TITLE: **CHANGE OF ZONE NO. 05068, The Woodlands at Yankee Hill Planned Unit Development,** requested by Carl Schmidt, Midwest Net Lease Investors and SAP-SE, LLC, for a change of zone from AG Agricultural District to R-3 Residential District, and to develop 500 dwelling units and 324,000 sq. ft. of commercial and office floor area, on approximately 194.83 acres, more or less, generally located southeast of the intersection of South 70th Street and Yankee Hill Road.

LINCOLN CITY/LANCASTER COUNTY PLANNING STAFF REPORT

<u>P.A.S.:</u> Annexation #05015
<u>Change of Zone #05068 - The Woodlands at Yankee Hill PUD</u>

<u>PROPOSAL:</u> To annex approximately 212 acres of land and change the zoning designation from AG to R-3 PUD on 163 acres, and approve a development plan for 1,000 single-family dwelling units, 450 multiple-family dwelling units, and 485,000 square feet of office/commercial floor area.

PROPOSED JENSEN PARK ESTATES (PRELIM. PLAT)
CITY LIMIT
N
NO SCALE
B-5
B-5
AGR
AGR
H-4
AG
AGR
I-1
H-3
P
R-2
I-1
CITY WATER TOWER
P
Area of Application
CITY-OWNED LAND TO BE ANNEXED
FUTURE JENSEN PARK (CITY-OWNED PARK SITE)

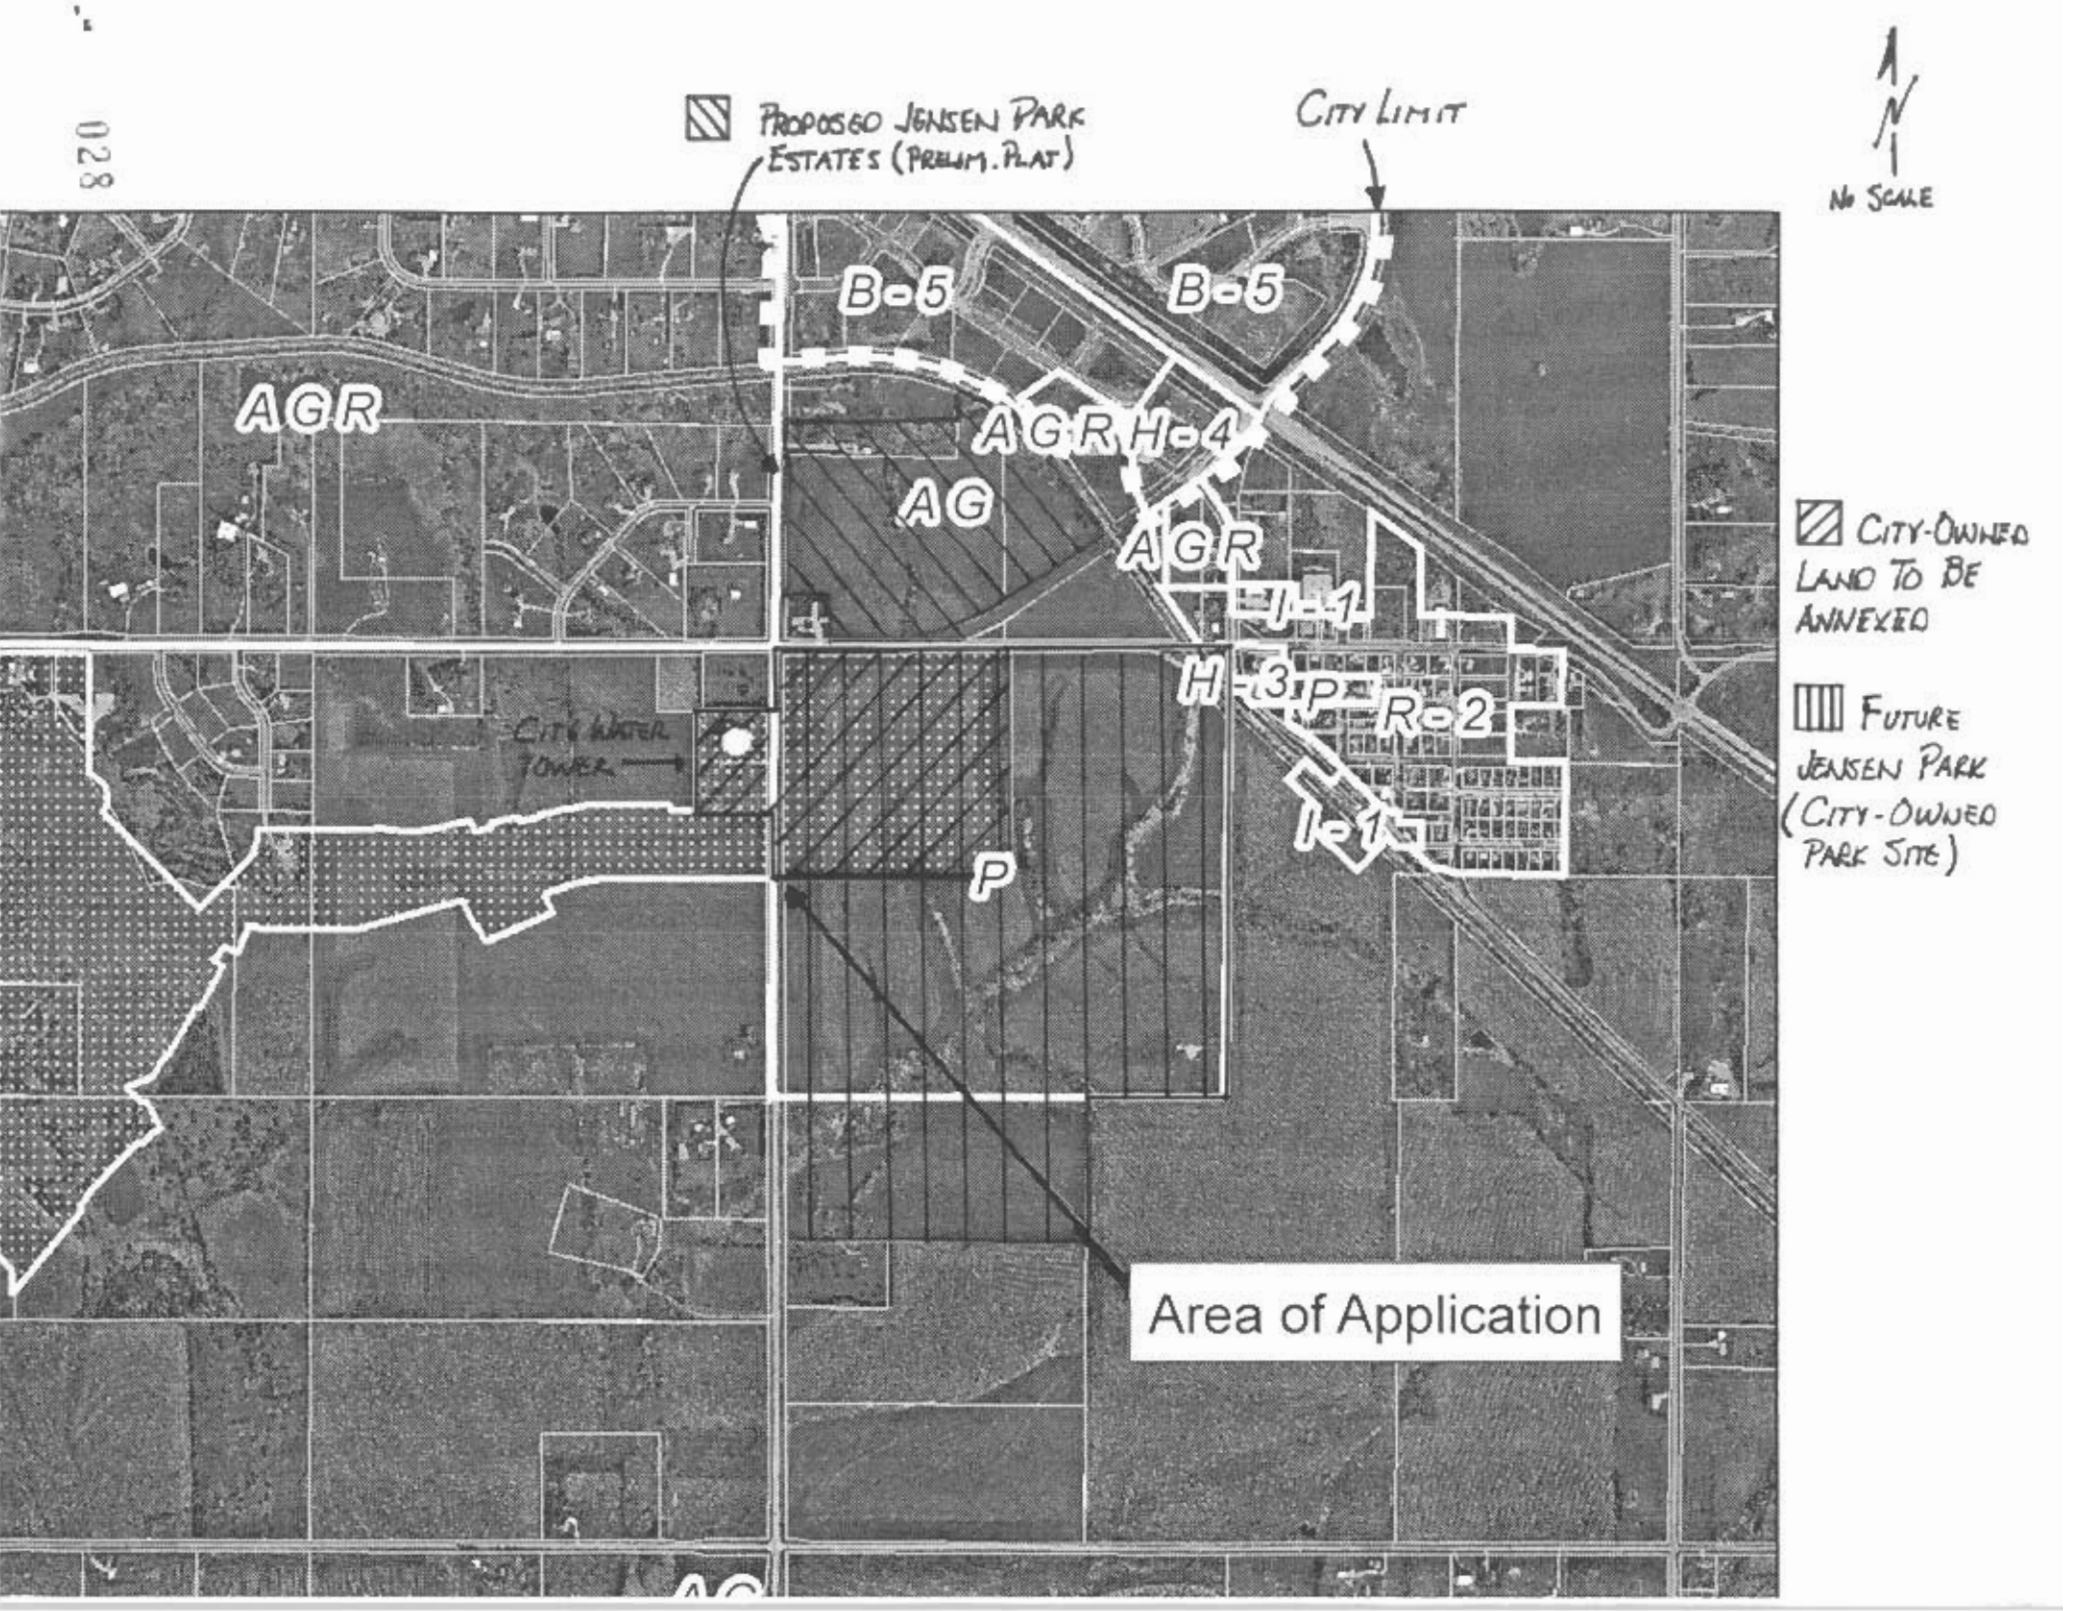
1. The site plan submitted shows a conceptual layout for the entire 357 acre Woodlands at Yankee Hill development. However, the project is to be phased, and these requests for annexation and a PUD only apply to that portion of the site which is shown as a shaded area on Sheet 1 of 5 of the attached site plan. The unshaded portion is a future Phase II.

C. Block length - The blocks that exceed 1,320' are Blocks 1, 2, 35, 38, 40, and 43. The waiver is appropriate for Blocks 1, 2, and 35 as the individual site plans will be approved by administrative amendment and an suitable internal private drive or roadway system can be required. The waiver is also appropriate for Block 40 because a street connection through the drainage/wetland area is not desirable. Acceptable street connections within Blocks 38 and 43 to eliminate the excess length can be made and the waiver is not appropriate.

10. The bike trail system is shown in the Comprehensive Plan to extend along both South70th Street and Yankee Hill Road in this area. The site plan however shows the trail meandering through the site to connect to the proposed Jensen Park site to the east. The route and location of the trail must be approved by the Parks and Recreation Department and shown as part of the plan prior to approval of any final plats. If the trail is located adjacent to the arterial streets, an additional 6' of right-of-right must be provided to accommodate it. A sidewalk must also be provided along the east side of South 70th Street where the bike trail is not adjacent to the street. In those areas where the plan shows the trail in known wetlands, it must be relocated out of them.

11. Parks and Recreation also notes that parkland is required to be dedicated as part of the PUD. The site plan must be revised to show the required parkland in a location suitable to Parks and Recreation.

13. The Health Department notes that there is an underground high-pressure gas line in this area. The location of the pipeline must be shown on the plan, and the Health Department recommends that all property owners within 200' of the pipeline be notified of the pipeline's location. The Health Department also notes past problems with the septic systems in the Walnut Heights subdivision just north of the proposed PUD and recommends the area be annexed at this time. However, this area will not be adjacent to the city limit with the proposed annexation, but could be appropriate for annexation at such time the surrounding areas are annexed, likely as part of Phase II of this project.

(3.2) Proposed grading contours have not been provided with this submittal. Since street grade profiles and storm sewer design calculations have been shown on the plans, the proposed grading contours need to be provided in order to conduct a proper review. If the proposed grading is not to be provided with this submittal, Public Works does not approve the street grade profiles or storm sewer calculations and reserves the right to require revisions to the street grades and storm sewer design information in required subsequent administrative amendments.

(3.3) The required minimum flood corridor easements need to be shown on these plans.

(3.4) The current FEMA floodplain needs to be shown on these plans. The plans indicate grading that will potentially raise flood plain elevations. The "no net rise" requirement will need to be addressed.

(4.1) The street system is satisfactory for a conceptual PUD. However, there is not enough information to determine design standard conformance for the street system in this PUD. Curve data and tangent lengths are not provided. Street grades are provided, however, since site grading has not been provided and adequate lot drainage cannot be verified, it cannot be determined whether or not the street grades are satisfactory. If this information is not to be shown on these plans, Public Works does not approve the street layout or street grades and reserves the right to require revisions to the street system and street grades at such time as a the information is provided with subsequent administrative amendments and a proper review is conducted. If the applicant wishes to have the street system and street grades approved with this submittal the PUD will need to be resubmitted with the required information.

(4.2) The submitted traffic study indicates the need for 300' of storage for the north bound left turn lane in 73rd Street at Yankee Hill Road. It appears from the plans that the driveway stub to the west is significantly closer to Yankee Hill than the 300' indicated in the study. Although this is supposed to be a conceptual site plan, if a driveway is to be shown, it should be located at the required distance or the median in 73rd Street should be shown extended past the driveway to the required spacing.

(4.3) The submitted traffic study indicates the need for a 150' north bound right turn lane in 73rd Street at Yankee Hill Road. It appears the turn lane shown is less than the 150' required. The plan needs to be revised to show the required length of turn lane.

1.□Detention calculations for this site must be submitted and reviewed with future amendments to this plan. Detention locations shown on this plan may not be adequate and may require larger ponds or ponds in other locations that may impact the lot layout shown.

2.□A "Minimum Flood Corridor" is required along the main tributary that runs through this development. The "Minimum Flood Corridor" for this tributary must be delineated and shown on the plan.

3.□The floodplain delineation shown on the plan sheets is noted as being from the Beal Slough Master Plan. This is not the floodplain that should be shown. The draft FEMA floodplain and floodway along with the existing FEMA floodplain and floodway need to be shown on the plan sheets.

1.1.1 Revise the land use table to show a breakdown for Phases I and II and correct inaccuracies in floor areas shown..

1.1.5 Show a 20' setback around the perimeter of all office/commercial areas.

1.1.7 Show the extension of streets 300' beyond the boundary of the PUD, and revise the street layout to eliminate the need for block length waivers for blocks 38 and 43.

1.1.8 Show the bike trail in a location approved by the Parks and Recreation Dept.

1.1.9 Show parkland to the satisfaction of the Parks and Recreation Dept.

1.1.10 Show the high-pressure gas line and delineate the 220' hazard area.
